### **STAFF REPORT**

**APPLICATION RZ 2015-HM-005**

**HUNTER MILL DISTRICT**

<b>APPLICANT:</b>	Pulte Home Corporation
<b>EXISTING ZONING:</b>	I-4 (Medium Intensity Industrial)
<b>PROPOSED ZONING:</b>	R-30 (Residential, 30 du/ac)
<b>PARCEL:</b>	18-3 ((6)) 5
<b>SITE ACREAGE:</b>	1.58 acres
<b>PROPOSED OPEN SPACE:</b>	19%
<b>PLAN MAP:</b>	Residential Mixed Use
<b>15.2-2303.4 STATUS:</b>	Exempt: Reston
<b>PROPOSAL:</b>	To rezone from the I-4 District to the R-30 District to permit a total of 44 multi-family dwelling units at a density of 27.8 dwelling units per acre (du/ac)

GENERAL  
DEVELOPMENT  
PLAN

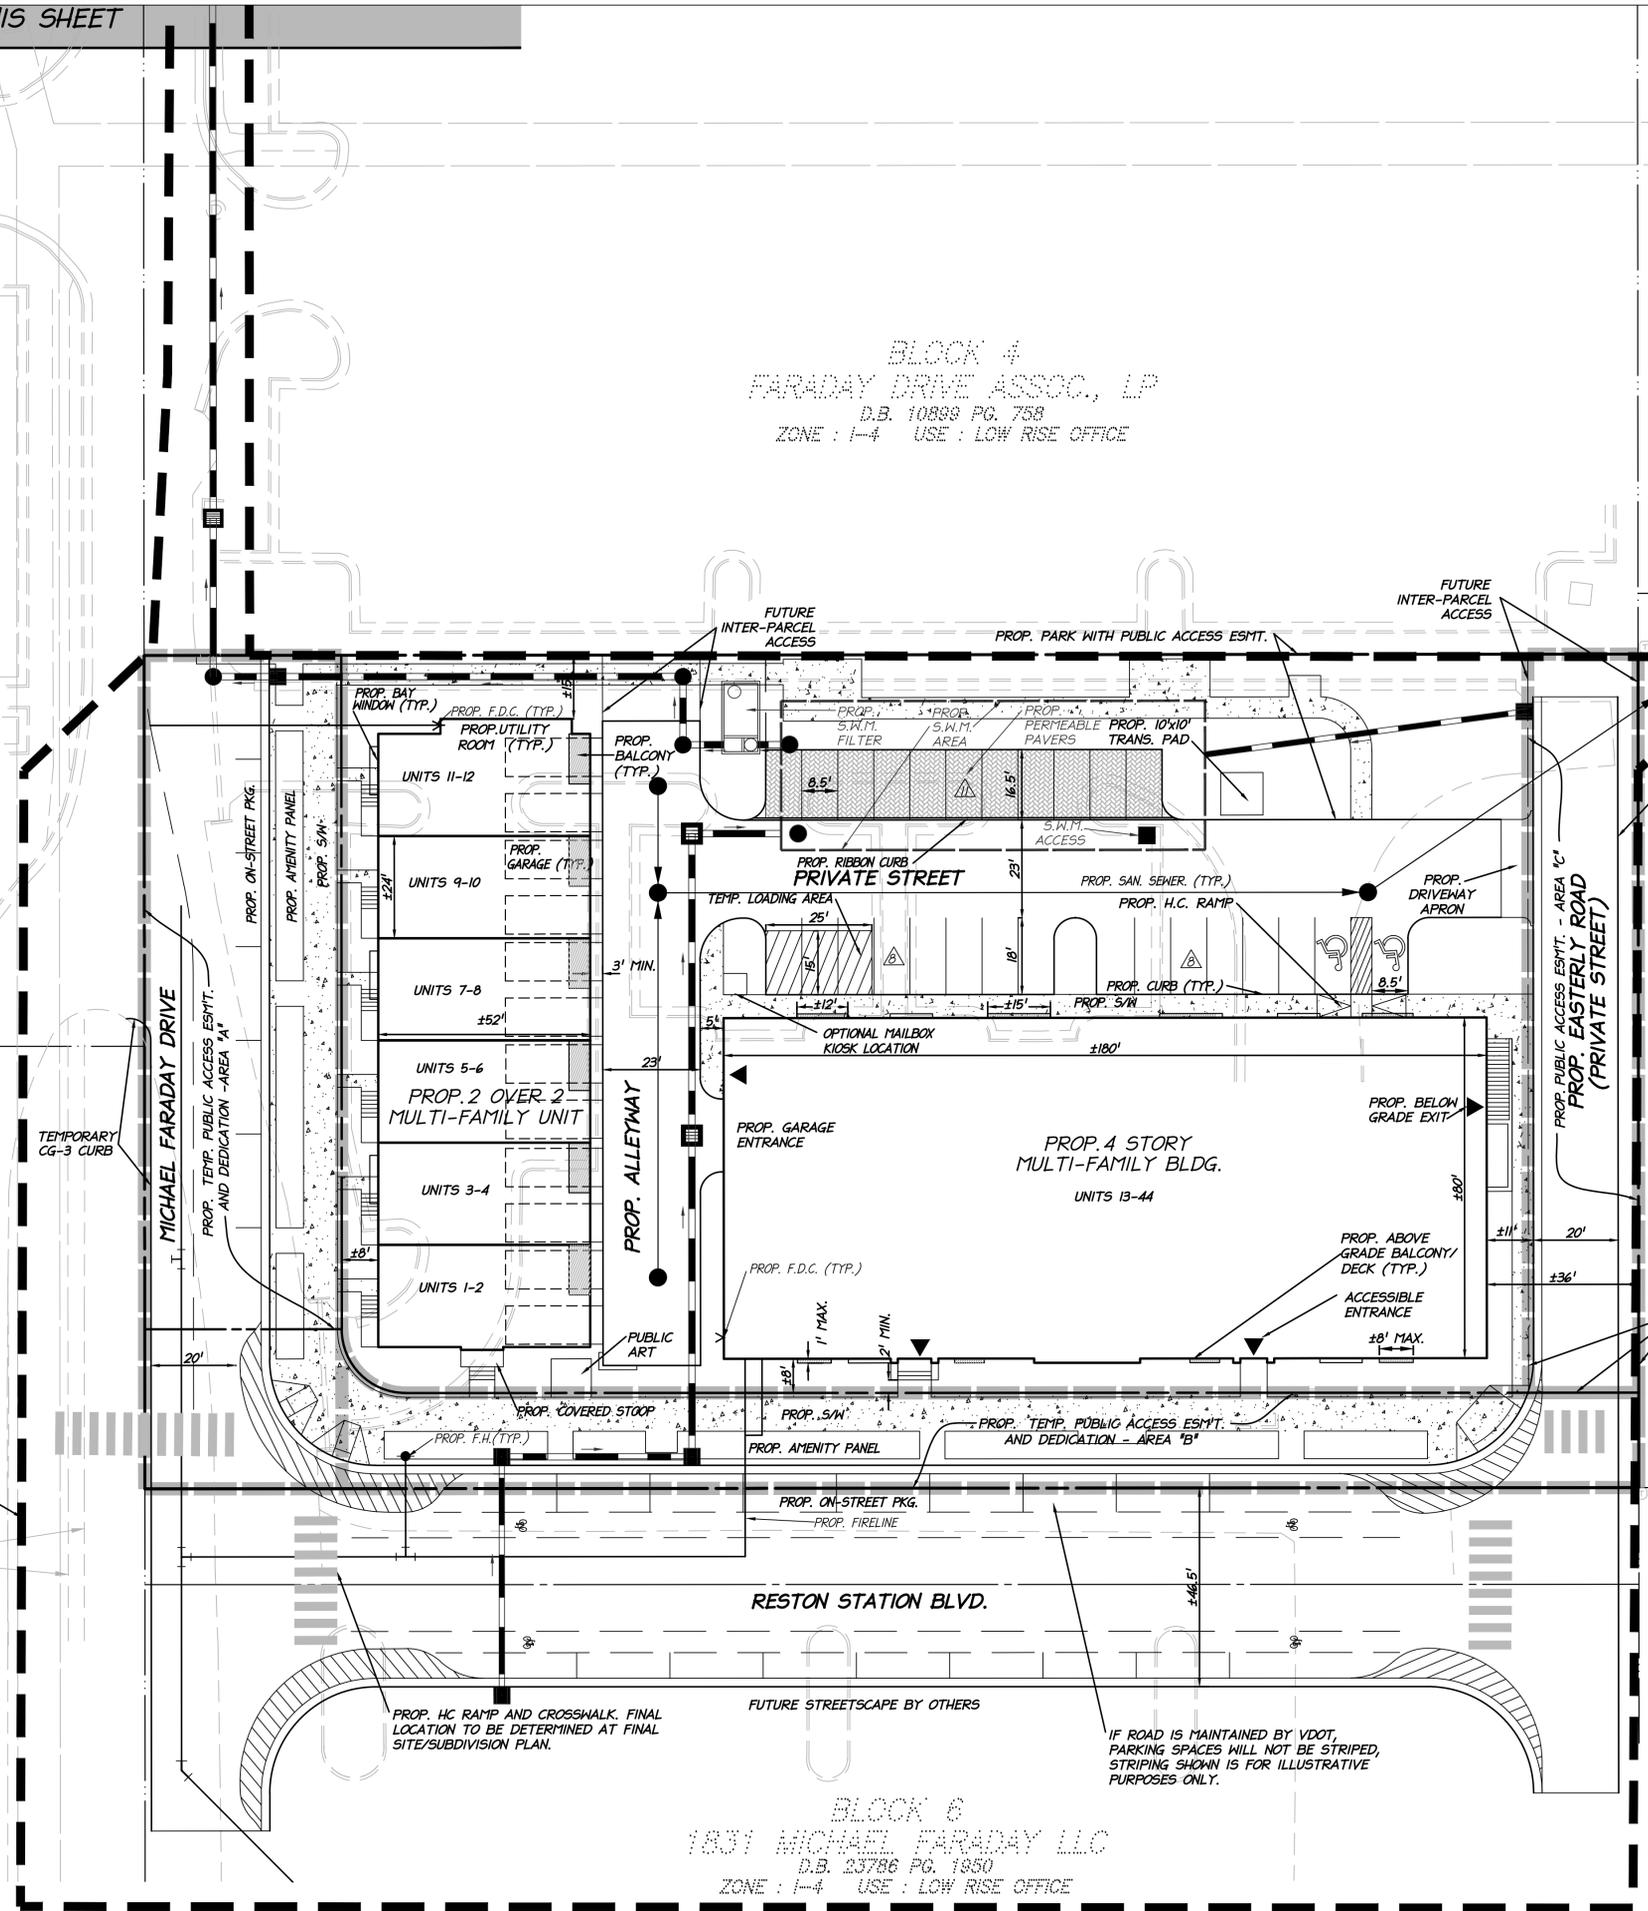
- B. Right-of-Way Dedication. Upon the written request of the County, the Applicant shall dedicate the right-of-way shown as “Prop. Temp. Public Access Esm’t. and Dedication – Area A” on Sheet 3 of the GDP in fee simple to the Board of Supervisors for public street purposes. The Applicant shall use good faith efforts to pursue the vacation of the existing private ingress-egress easements recorded in Deed Book 2531, at Page 199, Deed Book 3006, at Page 605, and Deed Book 4775, at Page 139, prior to such right-of-way dedication to the Board of Supervisors. The Applicant shall maintain such dedicated area up and until the time the street is accepted as a public street; the Applicant shall have no obligation to get the street accepted by VDOT as a public street.

- C. Construction of Half-Section of Michael Faraday Drive. The Applicant shall construct a one-half section of Michael Faraday Drive and the associated streetscape elements as shown on Sheet 3 of the GDP prior to the issuance of the first Residential Use Permit (“RUP”) for the Proposed Development. Such one-half section shall consist of the pavement (but not any striping) for one-half of a center turn lane (5.5 feet), one travel lane (11 feet), one bike lane (5 feet), and one on-street parking lane (8 feet) for a total of 29.5 feet from the centerline of Michael Faraday Drive to the curb as shown on Sheet 4 of the GDP. Such streetscape elements shall consist of a landscape amenity panel (8 feet), a concrete sidewalk (8 feet), and a building zone (8 feet) for a total of 24 feet from the edge of pavement to the face of the adjacent residential building as shown on Sheet 4 of the GDP.

SCALE:  
 NTS  
 SHEET 5 of 12  
 DATE: JUNE, 2015  
 DRAFT: WOR/JMB CHECK: MTM  
 FILE NUMBER: 4019-1-1 3B

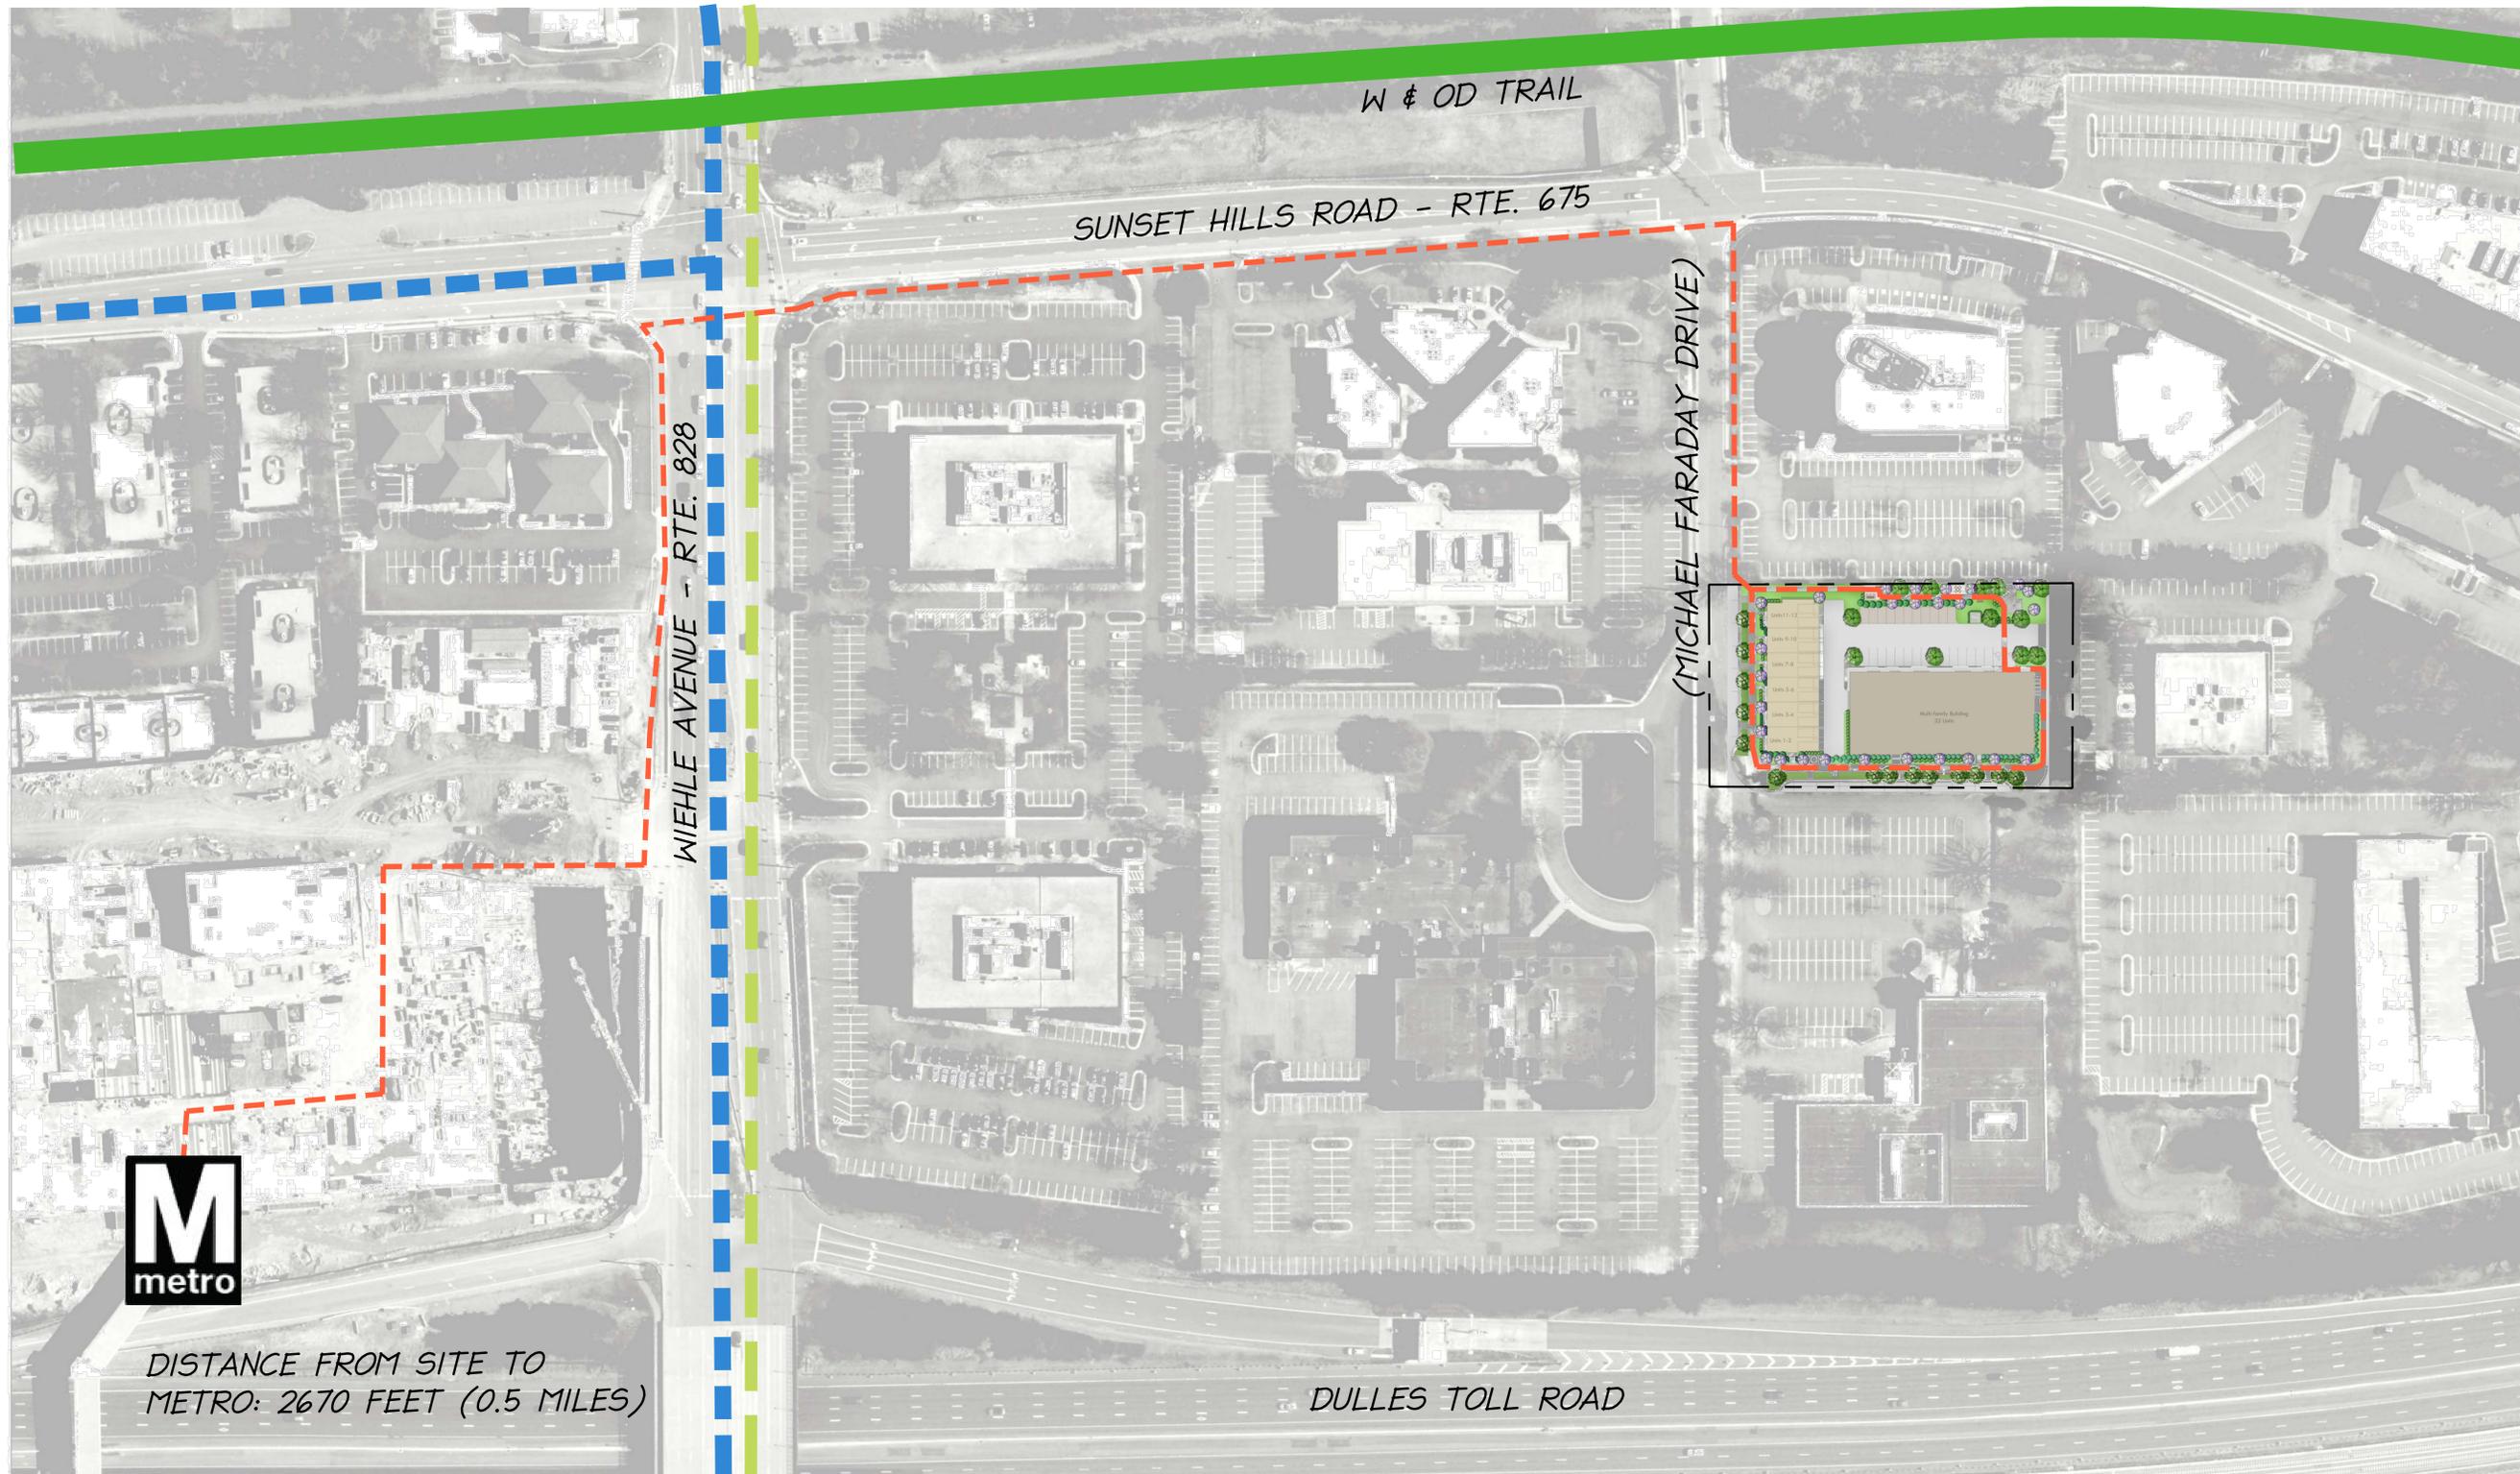
The illustrative layout on Sheet 5 of the GDP shows how the proposed development would fit into the expected layout of the greater quadrant. While this illustrative does not guarantee that the surrounding properties will develop in this manner, it demonstrates one possibility. The intent of such an illustrative is to demonstrate that there is at least one potential way for development in the quadrant to be organized in a cohesive manner. In this case, the illustrative shows how the small amount of open space located along the northern edge of the site might be expanded with redevelopment to the north. Even in this drawing, however, it is apparent that the minimal open space (even if expanded to the north) does not connect to any other significant open space. Additionally, as shown, development of the property to the north would result in the front doors of that development facing the surface parking lot of this development. The architecture shown on Sheet 8A of the GDP does demonstrate that the 'rear' of the building is detailed in a manner that is similar to the front, which is appropriate for this setting; however, the minimal open space and surface parking lot are not appropriate for the "front door" of the adjacent development. The illustrative in the GDP, therefore, does not adequately show that the proposed development will fit appropriately into the potential development pattern of the surrounding area.
